CSB-1067-2
 Country : UK
 Date : 11/1/2006
 APC : F77
 Repair Level : 2

Title W220 - GSM - W220 LCD missing line
 Model Effected W220

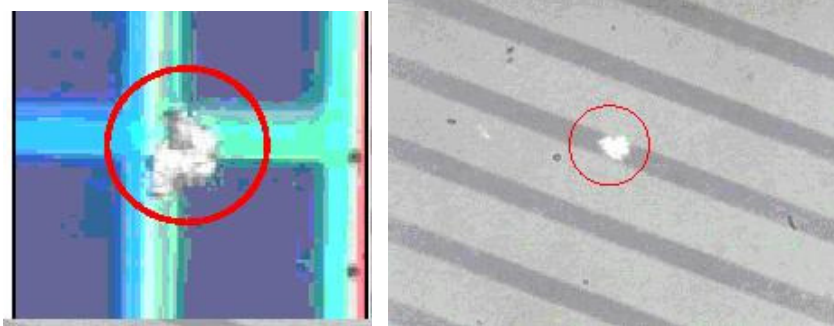
Root cause 1: There are metal particle in ITO cell. Via the SEM-EDS analysis, confirm it is Aluminum material.

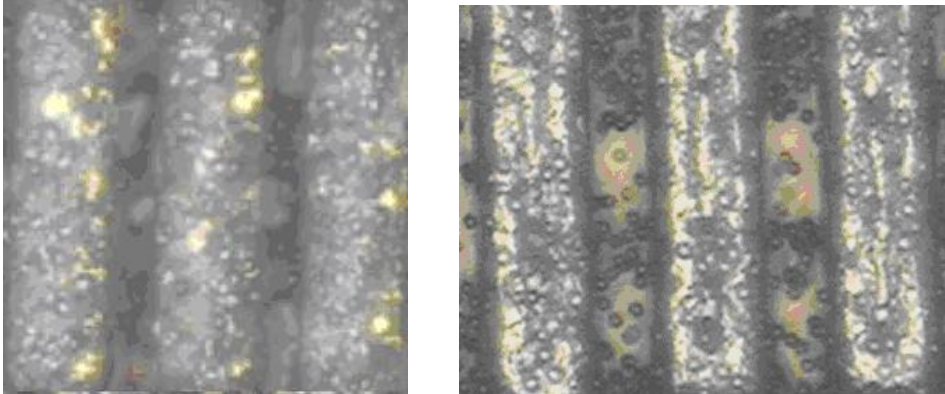
Root cause 2: There are conductive particle between OC golden bump and LCD ITO circuit.

conductive particle
incompletely breakable

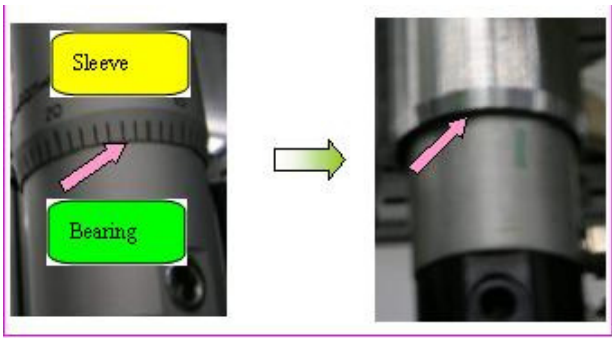
Corrective action for root cause 1:

Increase the diameter of sleeve to avoid the friction between sleeve and bearing on week 36.
 (LCM shipping date code: 40/06)

Increase the diameter of Sleeve
